RE: Eagle Gas Station  
4301 San Leandro Street  
Oakland, California 94601

Re: **Fuel Leak Case No. RO0000096**  
Proposed Modifications to Work Plan  
Eagle Gas Station  
4301 San Leandro Street  
Oakland, California 94601

Clearwater Group Project Numbers ZP046M and ZP046K

**Site Plan Showing Proposed Location of DPE Test**  
 Eagle Gas  
 4301 San Leandro Street  
 Oakland, California

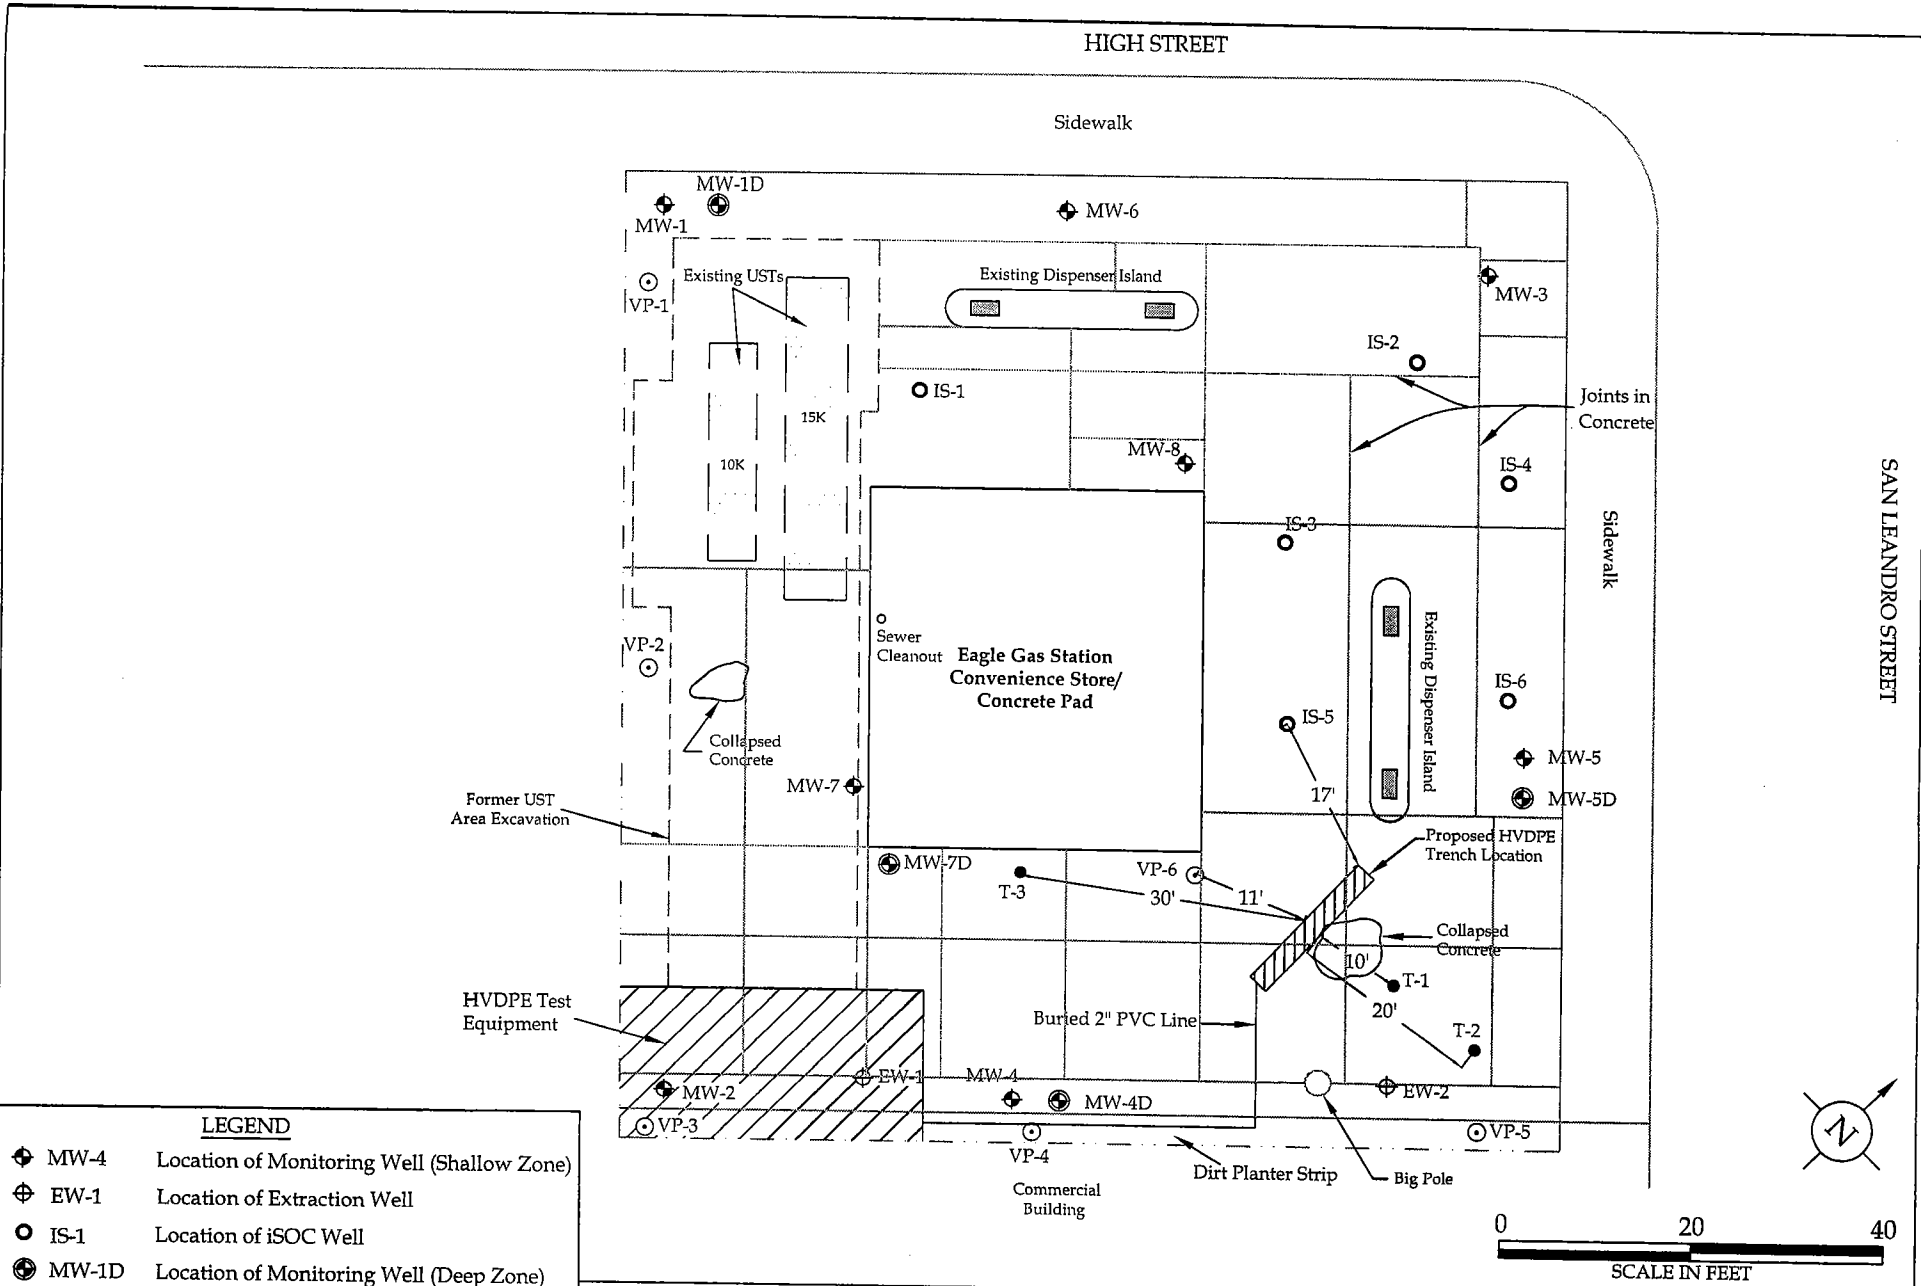
The design and location of the radius of influence DPE test wells (T-1, T-2, and T-3, **Figure 1**) are unchanged from the Work Plan design, and the depth of all the DPE well seals will be to a minimum of 5 feet below ground surface.

### Proposed DPE Test Trench Design

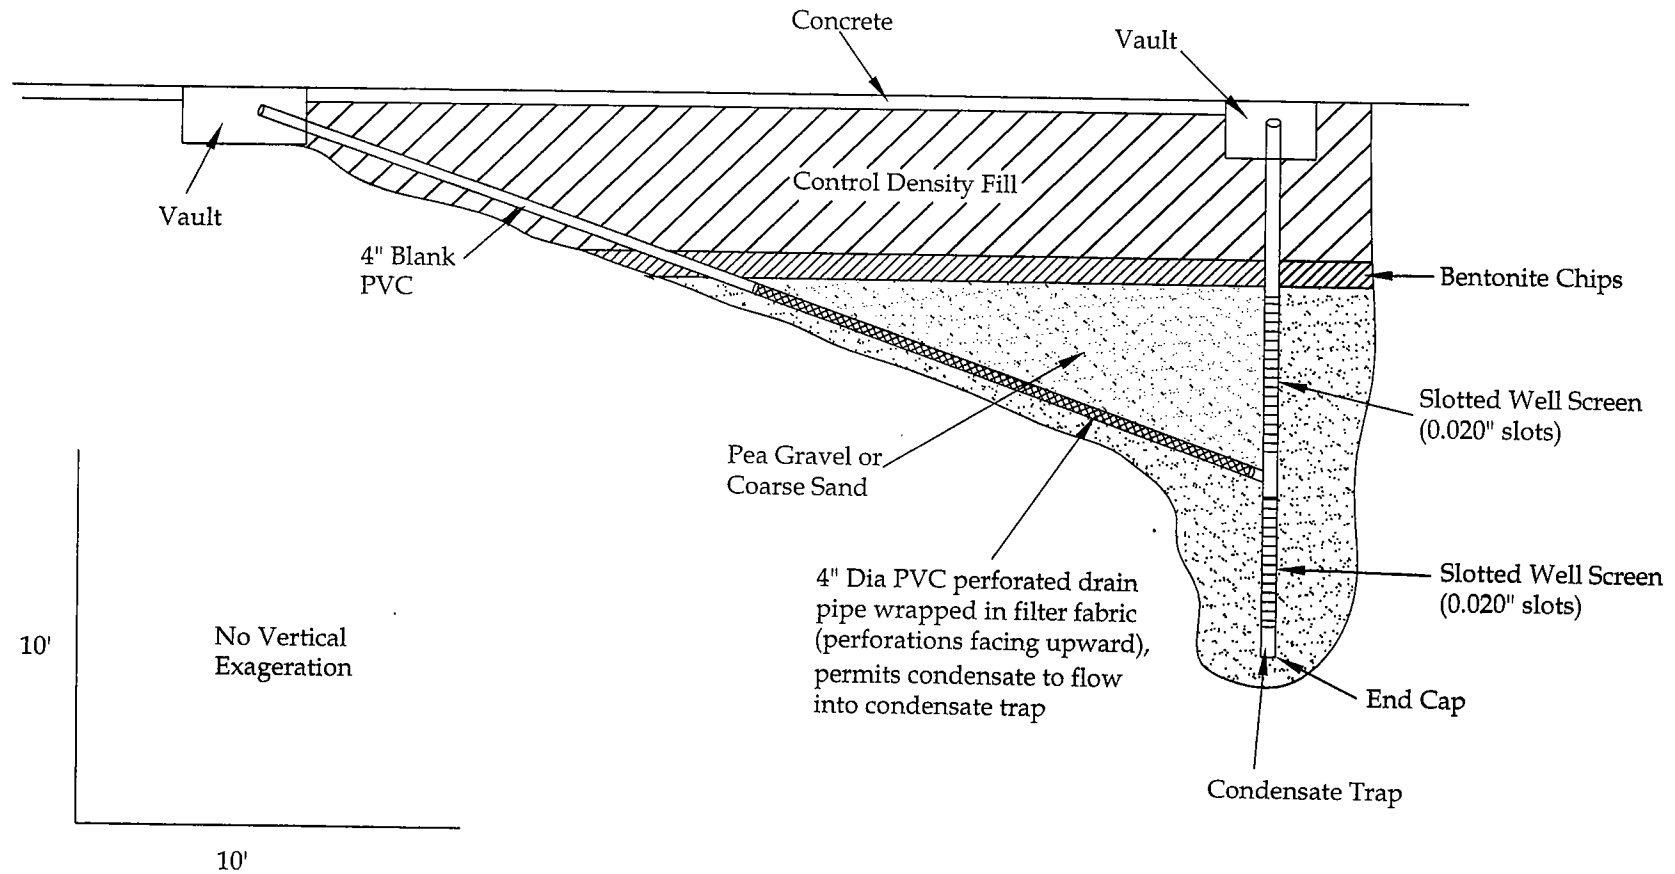
Clearwater has redesigned the DPE test design in response to these ACEH comments and with input from DPE contractors and designers. The revised DPE test design utilizes a slanted DPE extraction trench, rather than a vertical well. **Figure 1** presents the proposed location of the DPE test, and **Figure 2** presents a cross-section view of the proposed DPE test trench design. The DPE trench's one-foot thick bentonite seal will be set five feet below ground surface. In addition, the five feet of fill placed above the bentonite seal, to fill the trench, will be Control Density Fill (CDF), which consists of a soil/cement slurry. The CDF slurry is fluid enough to be poured into the excavation. Once the CDF cures, it forms a solidified soil mass, eliminating the need for soil compaction. Unlike cement, cured CDF is excavatable using a backhoe. The DPE test trench and monitoring wells will be installed under the supervision of a State of California C57 licensed well drilling contractor.

**Offsite Groundwater Monitoring Well Locations**  
 Eagle Gas  
 4301 San Leandro Street  
 Oakland, California

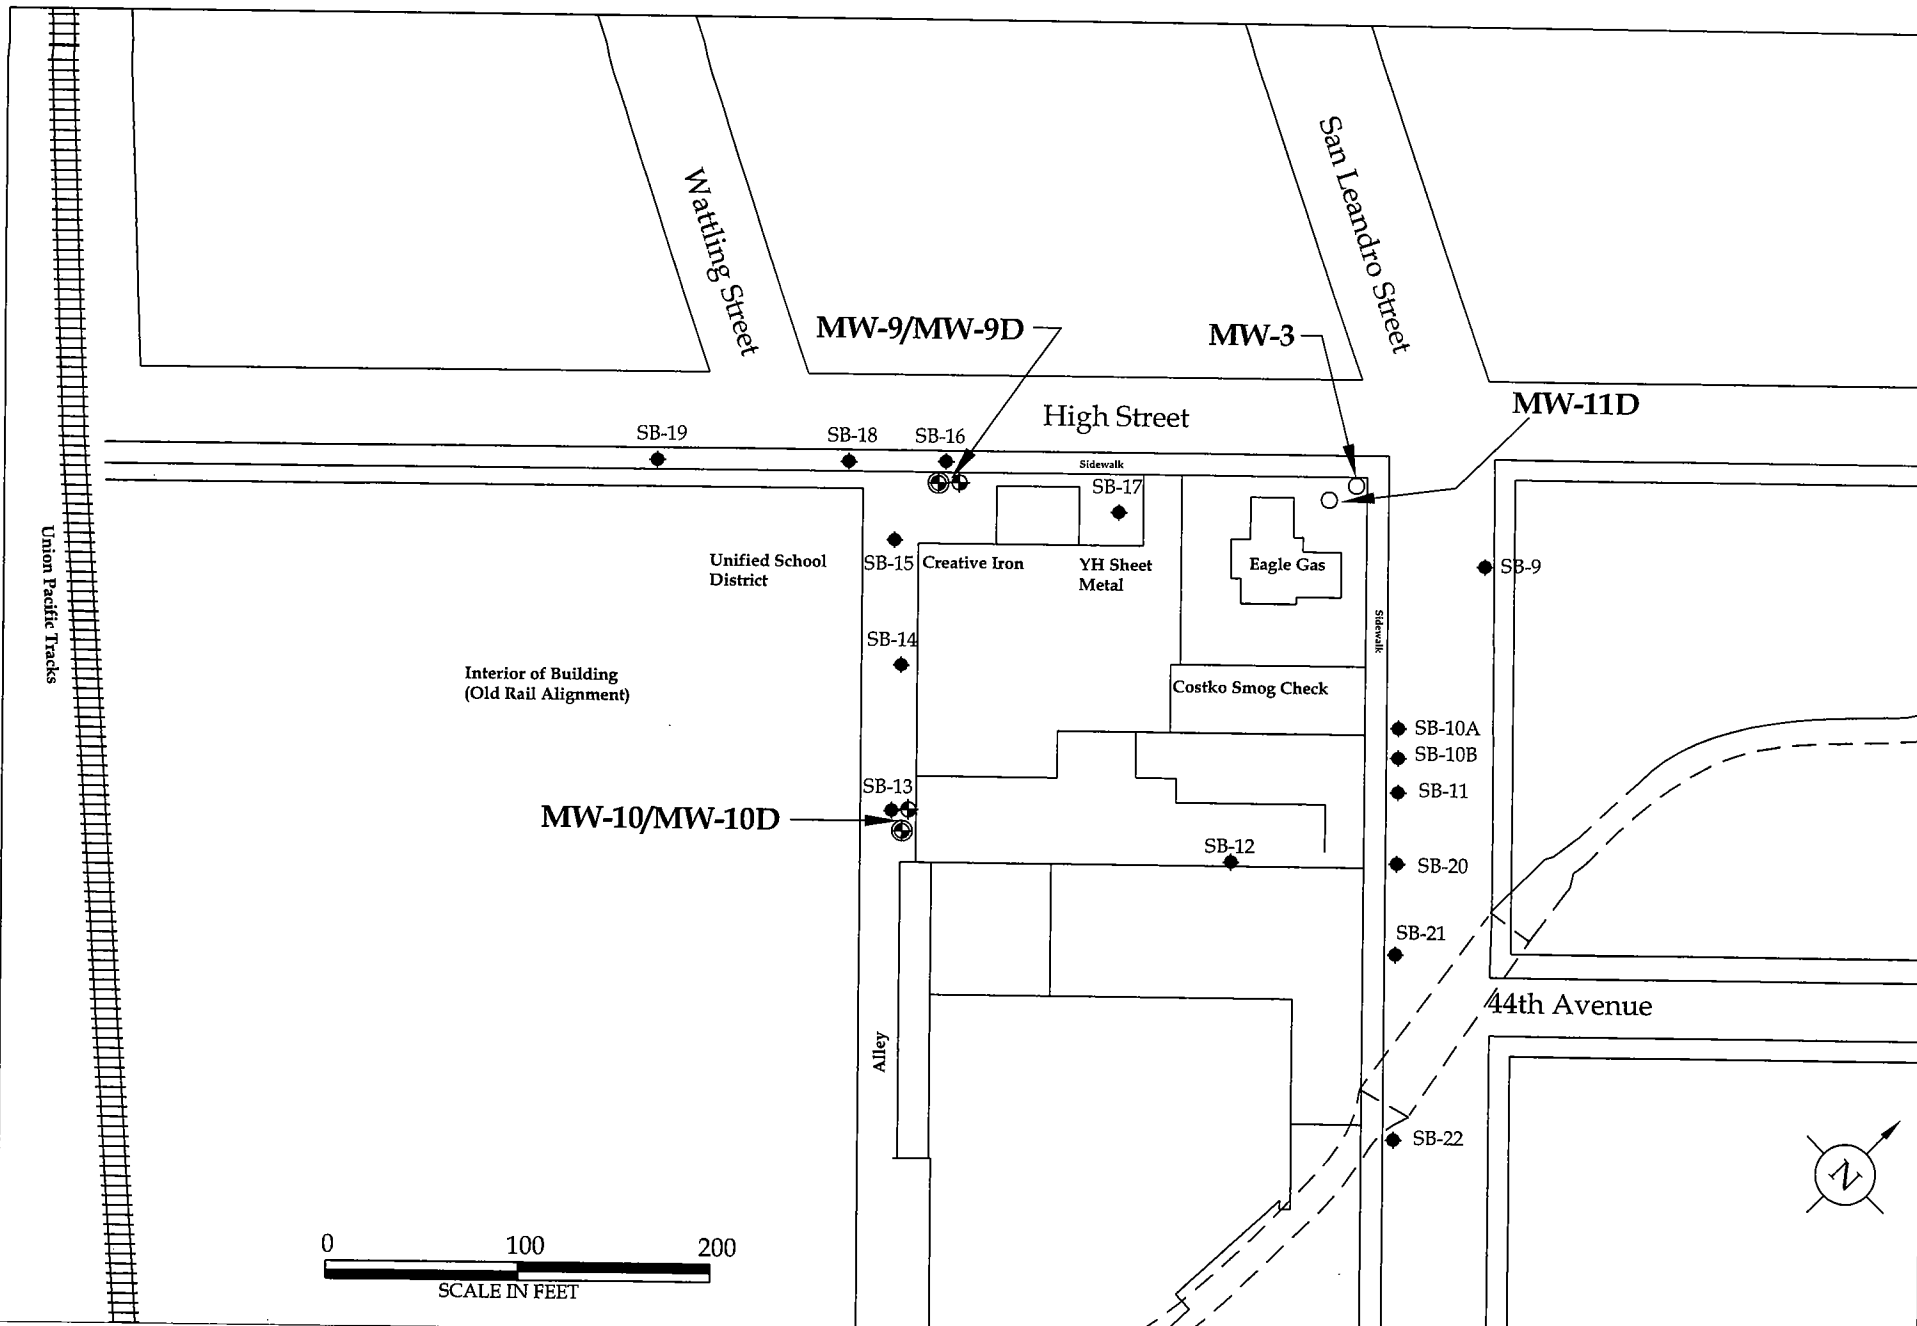
If low-flow sampling is acceptable, Clearwater requests a reduction in the number of wells sampled during each quarterly groundwater monitoring event. One problem of low-flow groundwater sampling is that it increases the time required to perform the quarterly groundwater monitoring events because of the longer purge time and increased equipment set-up and take-down time. The site groundwater has been monitored quarterly since October 2000, and Clearwater is concerned about the amount of funding remaining available for site remediation. Therefore, Clearwater proposes further reducing the number of wells sampled to five wells (MW-1, MW-3, MW-4, MW-8, and MW-7D [deep zone well]), in addition to newly installed groundwater monitoring wells MW-9, MW-9D, MW-10, MW-10D, and MW-11D (**Figures 2 and 3**).

Clearwater will merge the groundwater elevation data from the OUSD and Clorox sites, the onsite wells, and the newly installed offsite wells (well MW-9/MW-9D and MW-10/MW-10D; **Figure 3**) for future quarterly groundwater monitoring events.
